PLANNING COMMISSION

February 28, 2024 – 7:00 PM

From: Ken Roberts, City Planner

Re: Site Plan Review – Proposed Dental Clinic

Weathered Charcoal Blend

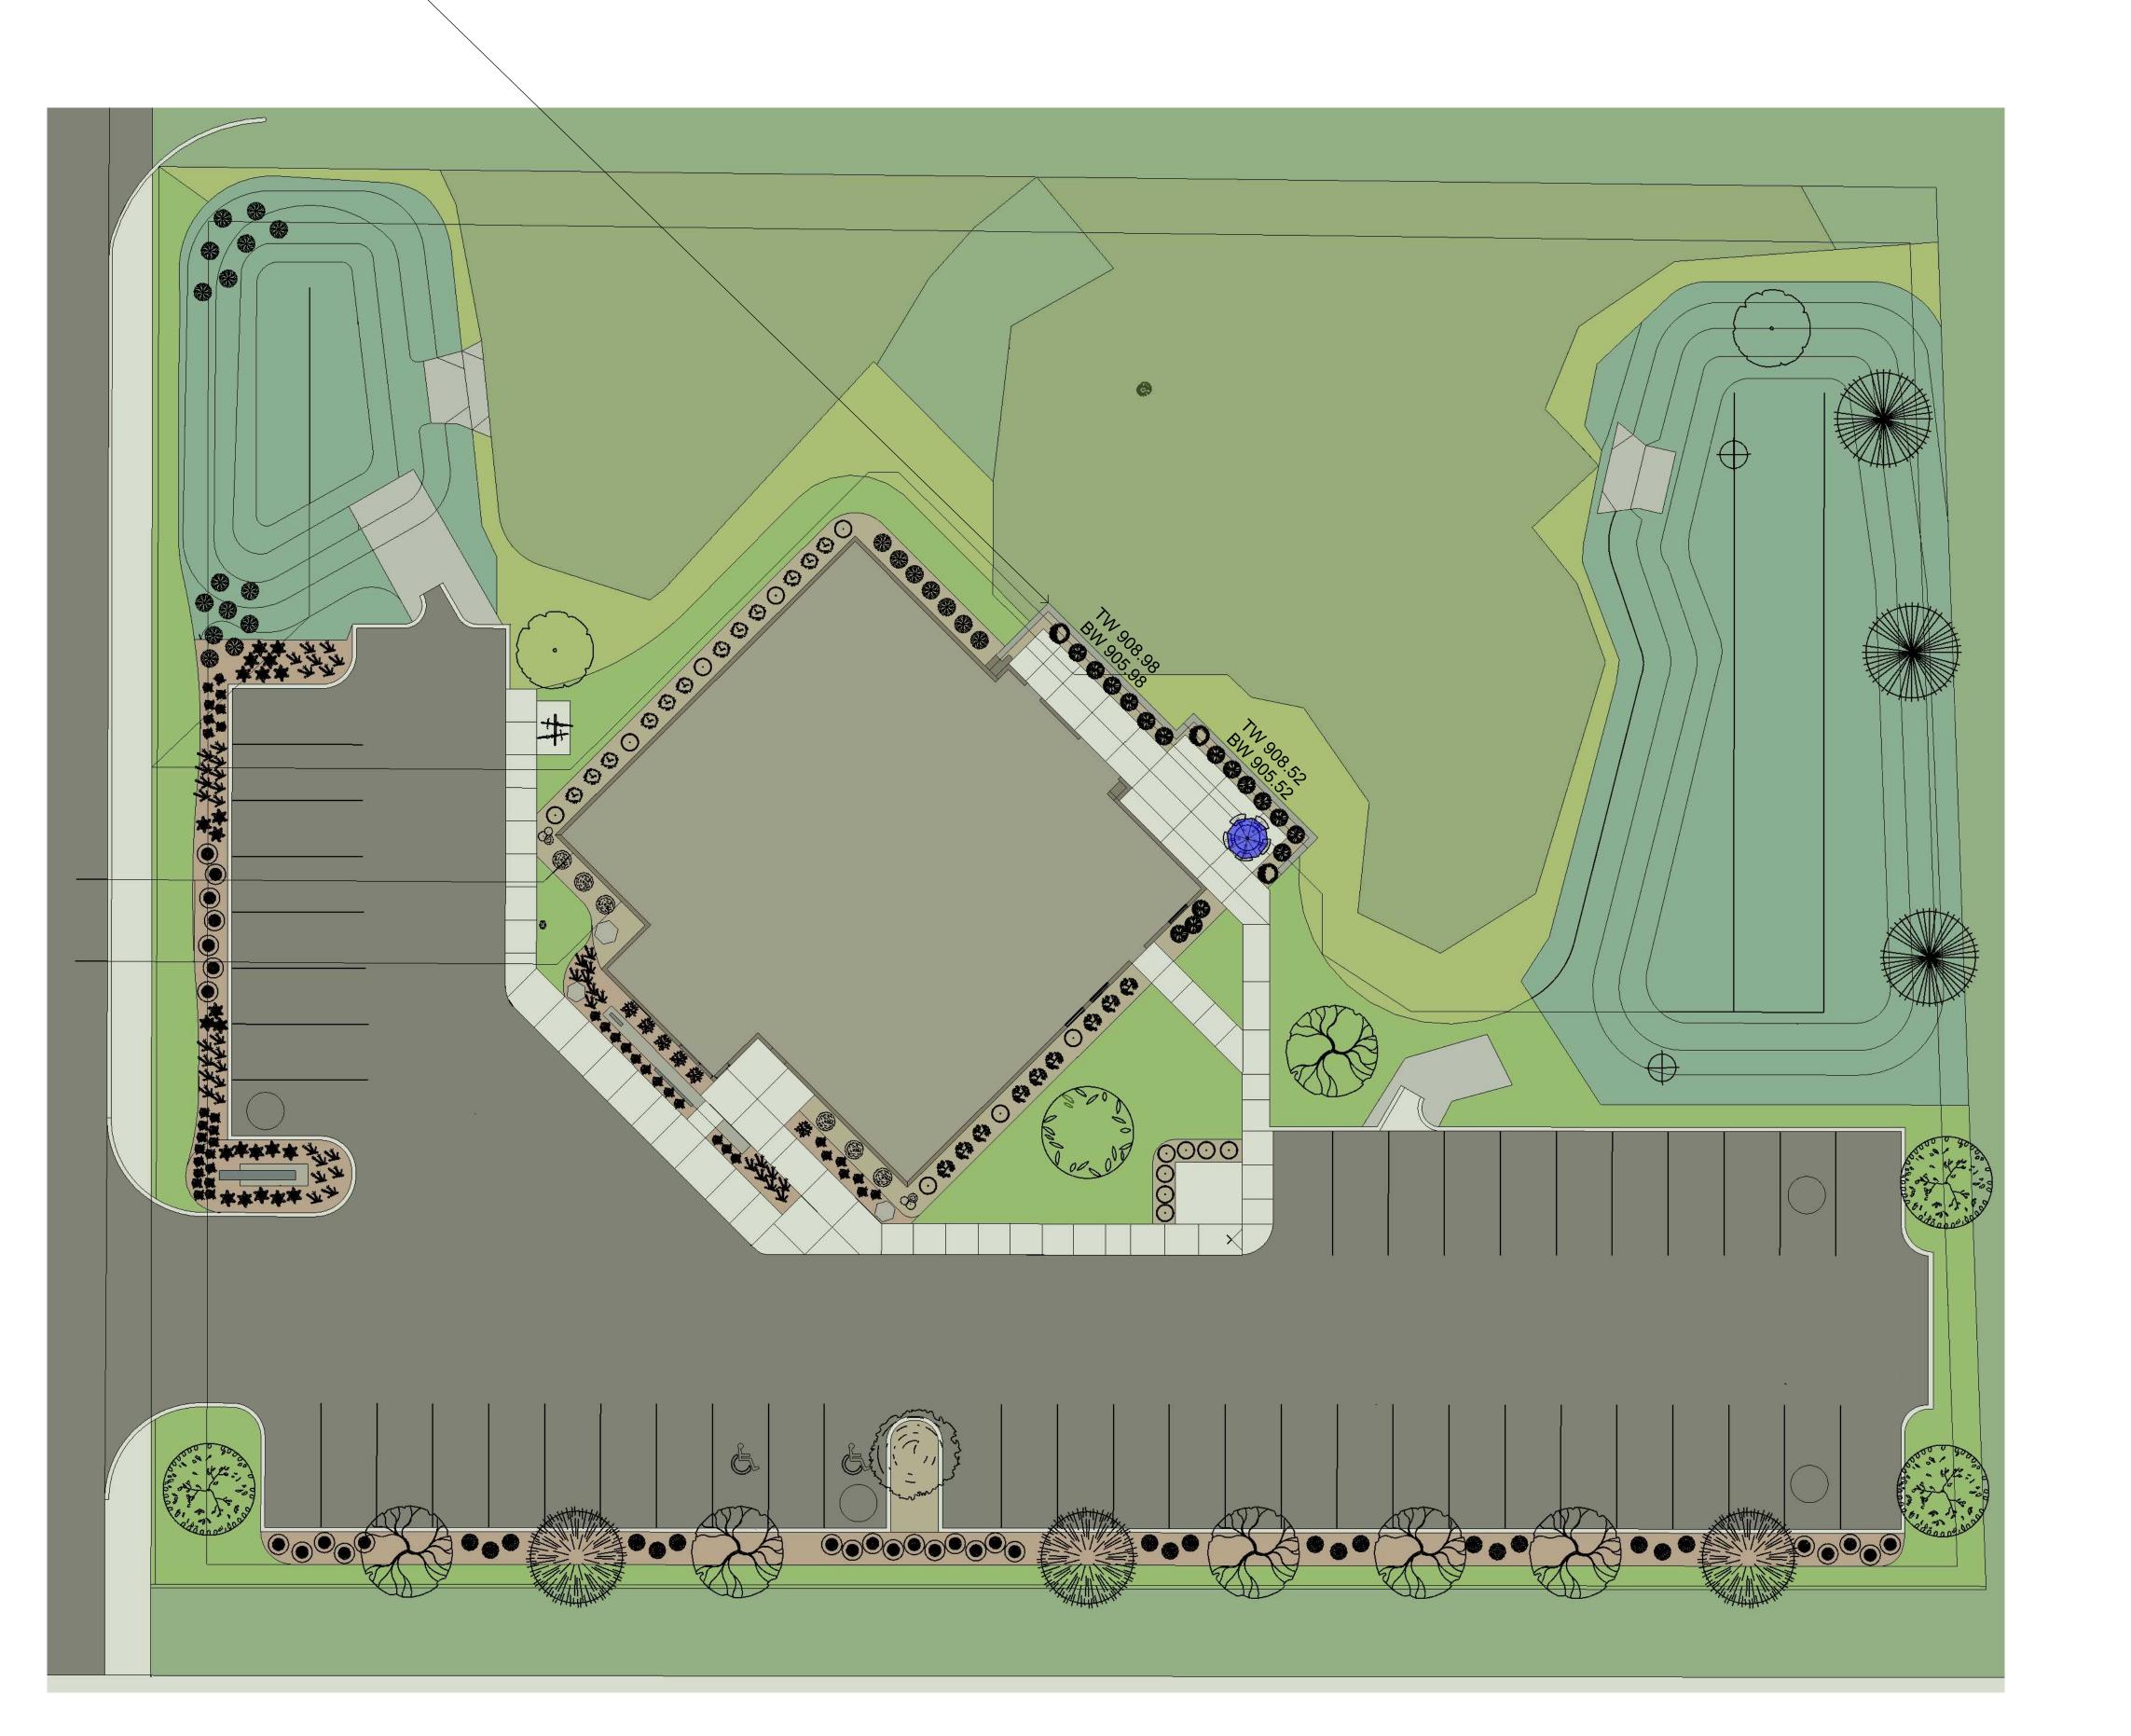
The proposed landscaping plan for the site (dated February 8, 2024) details three varieties of trees for the seven proposed trees considered to be overstory trees. The seven proposed overstory trees do not meet the City requirement of planting at least 33 trees for this site. The proposed landscaping plan also shows the potential for planting of another five trees depending on the final grades and soil conditions in those locations.

As noted in the table above, the proposed landscape plan for the project site includes 136 understory trees and shrubs, 36 more than the 100 plants required by the City Code. The landscape plans also show the planting of a variety of shrubs and perennials in the area between the parking lot and the sidewalk along Centennial Drive to meet the City screening requirements for parking areas.

City staff are aware it may be challenging for the applicant to plant 33 overstory trees on the property while meeting all City requirements and while keeping the new trees out of the existing wetland and the proposed storm water ponds. The goal of the City is to have a development with professional landscape design and installation with trees and plantings of a high-quality and quantity of plant materials. In all cases, City staff expect the landscaping of a new development to complement the project site, the existing natural features and existing development on adjacent parcels. In summary, the proposed and expected landscaping, with the changes recommended by City staff, should substantially conform with City landscaping standards and they will meet the intent of the landscaping design requirements found in

Landscape Irrigation – Section 153.235 (D) (5) of the Code requires the installation of an irrigation system for landscape areas as may be determined by a landscape architect. The proposed project plans do not show irrigation for any of the proposed landscape areas. The applicant should revise the project plans to show irrigation in the landscape areas that will need it to help ensure the plantings will survive and thrive. If the applicant wants to revise the landscape plans to show areas with plant materials that require little or no water as part of a sustainable design and thus will not need irrigation, they can submit the revised landscape plans to the City for approval.

- e. Irrigation in the landscape areas that will need irrigation to help ensure the plantings will survive and thrive.
 - f. The use of native plantings in the new landscape areas that are tolerant to harsh conditions.

- g. Additional tree and shrub planting wherever possible on the property that will not be in easements and will not interfere with the function or maintenance of the proposed storm water ponds.

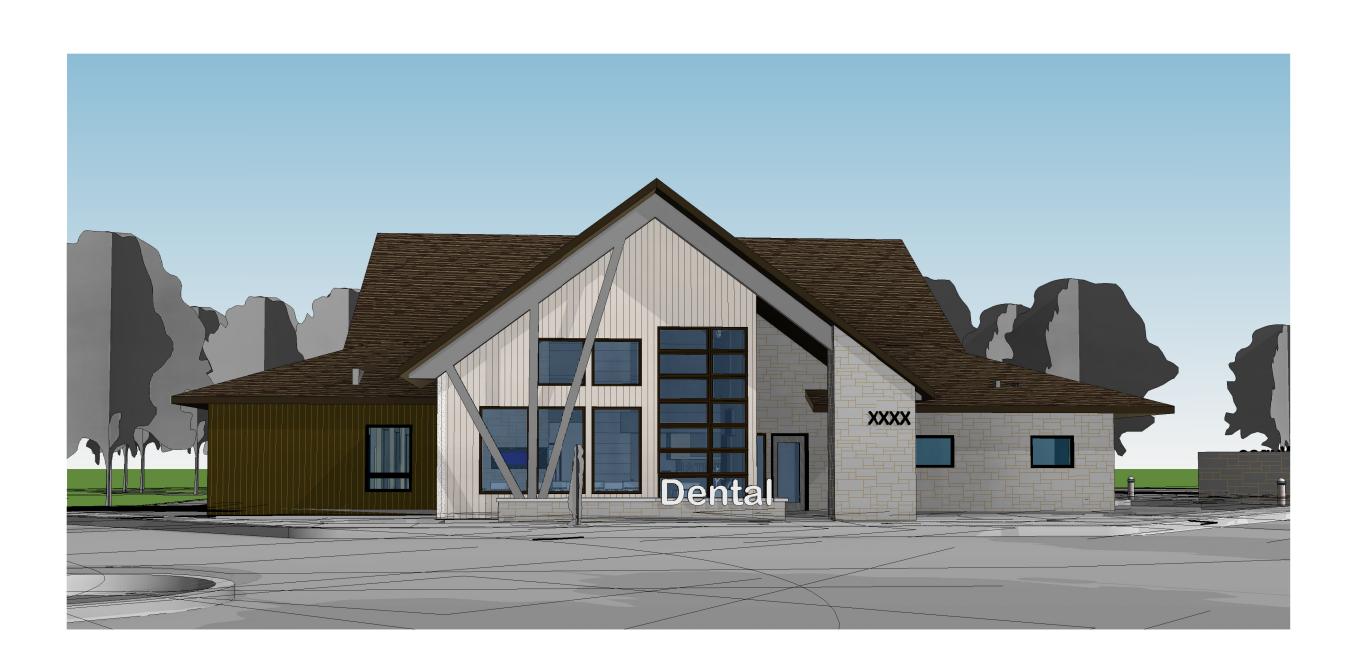
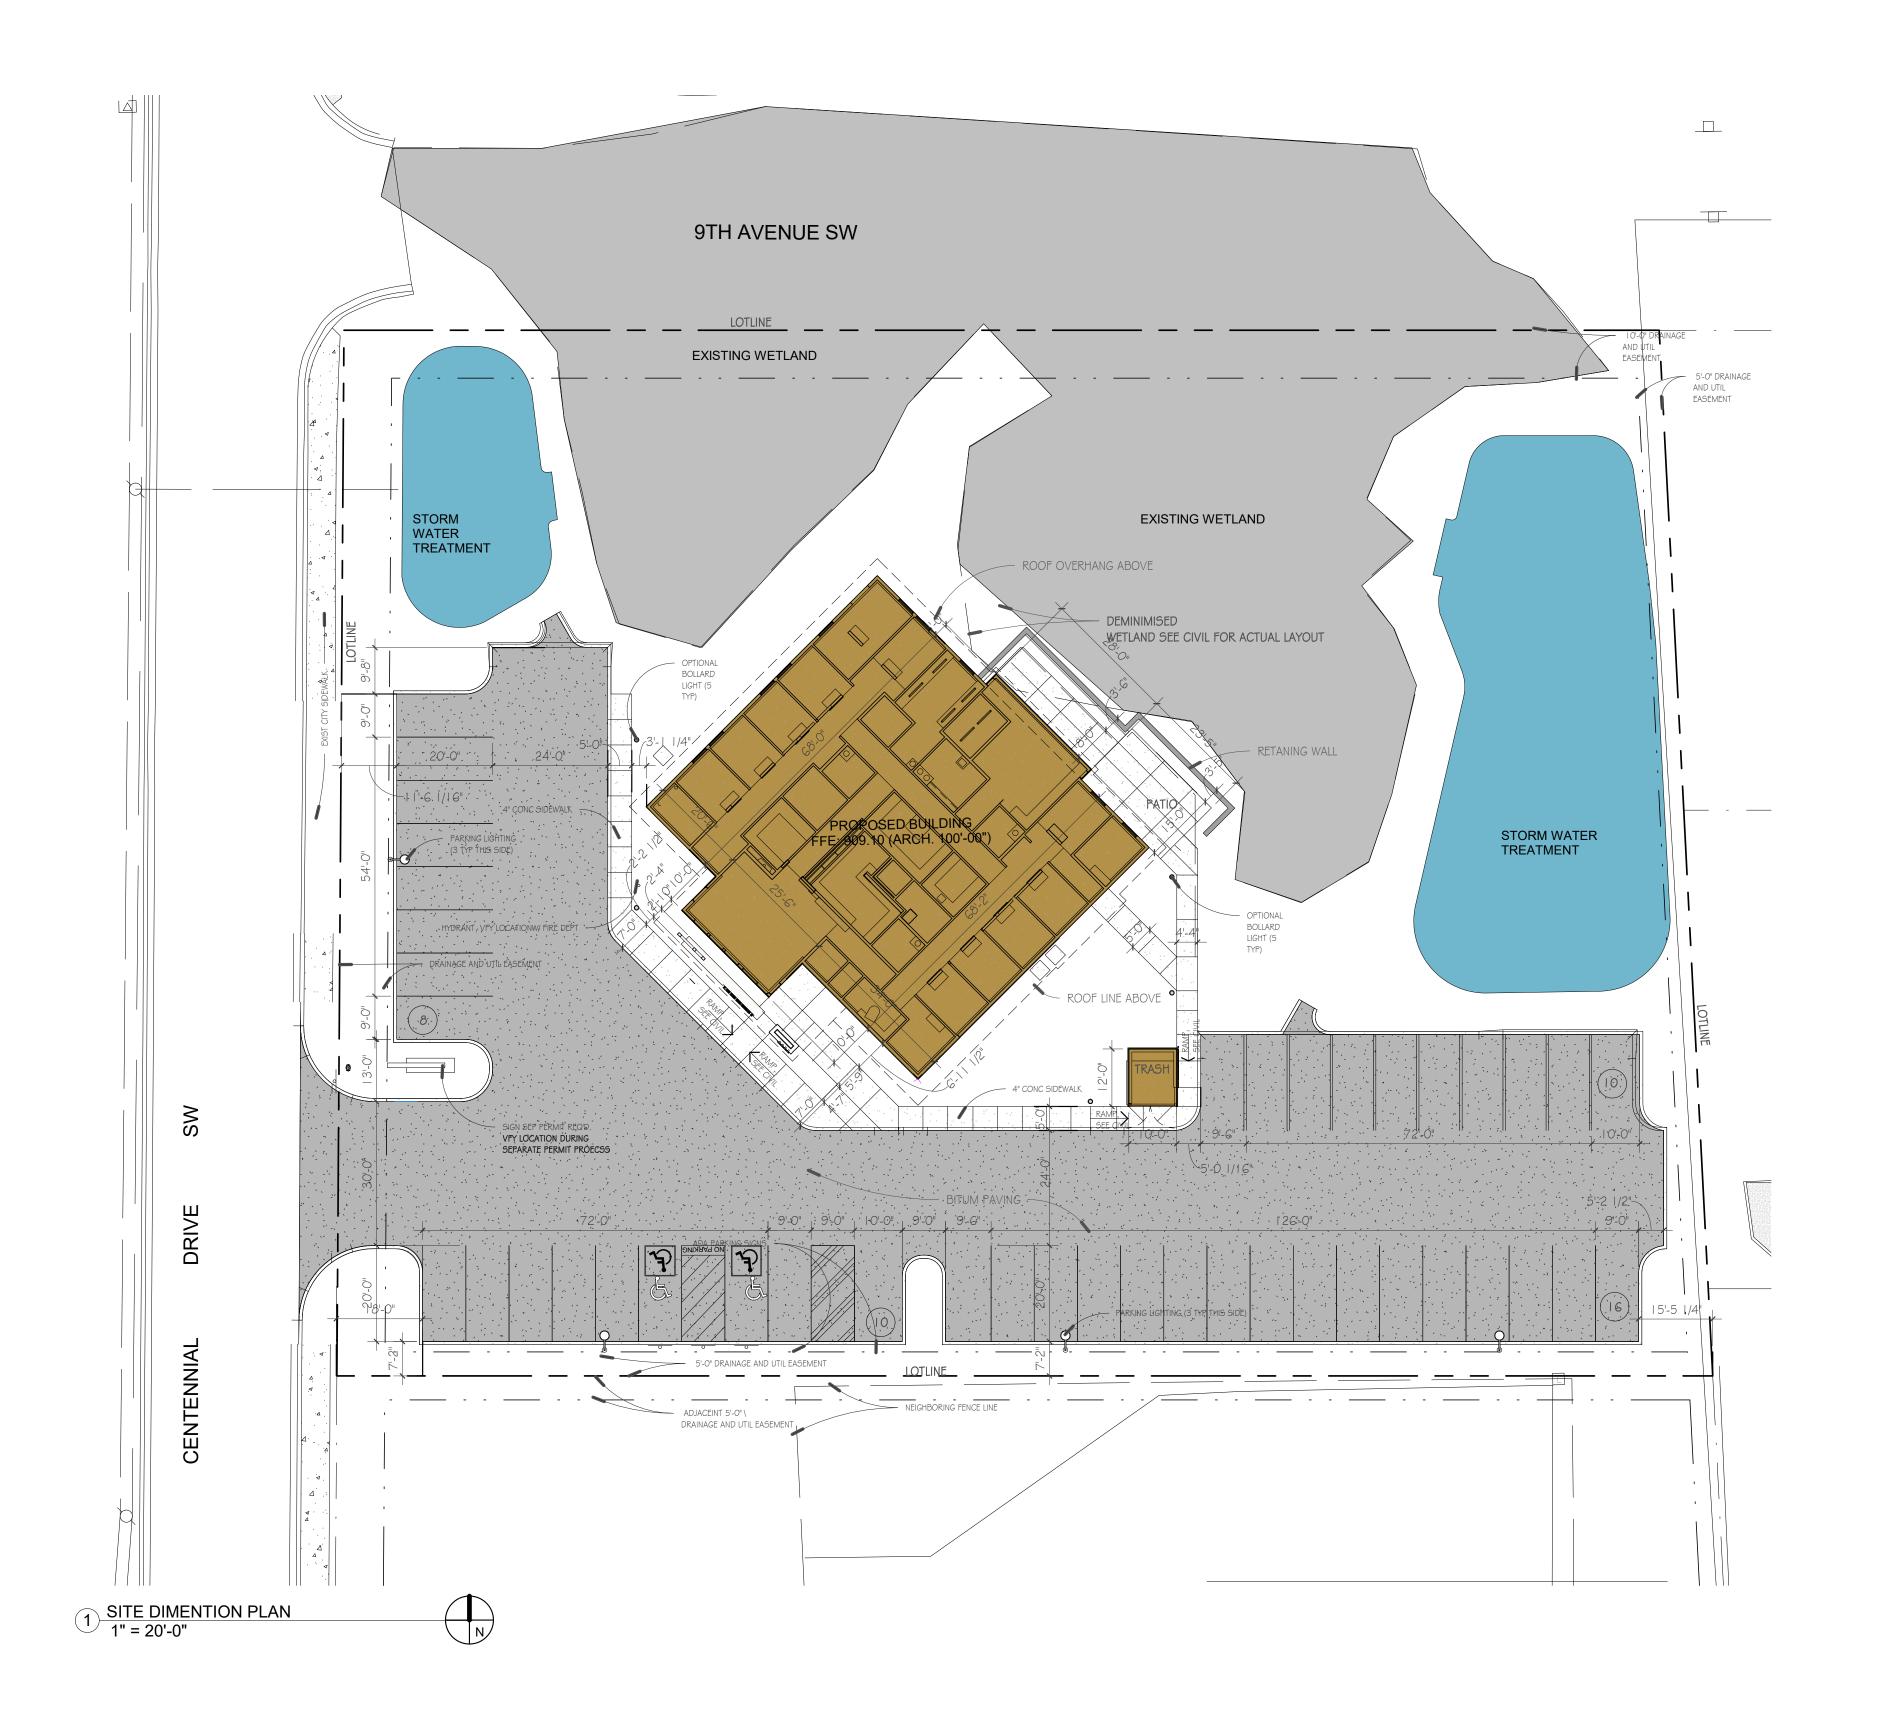
Lighting Plan – The City has established exterior lighting standards in City Code Section 153.185. The applicant's proposed lighting plan shows four free standing light poles in the new parking area and eight bollards with lights along the sidewalk adjacent to the building. The proposed lighting plan is <u>not</u> consistent with City standards for exterior lighting. The proposed lighting is shown to be up to 0.8 footcandles in strength along the south property line, which would be more intense than the City Code standard of a maximum of 0.4-foot candles or less at the property line. The height of two freestanding lighting poles is shown to be 22 feet which is lower than the maximum allowed height of 25 feet.

Staff is recommending the applicant submit to the City a revised lighting plan that meets all City standards before the City issues any permits for the project.

- a. A certificate of survey and a revised, detailed grading and drainage plan with the building permit for City approval.
 - b. An exterior lighting plan meeting the City's standards for exterior lighting in the MU-2 zoning district including not exceeding 0.4-foot candles at any property line.
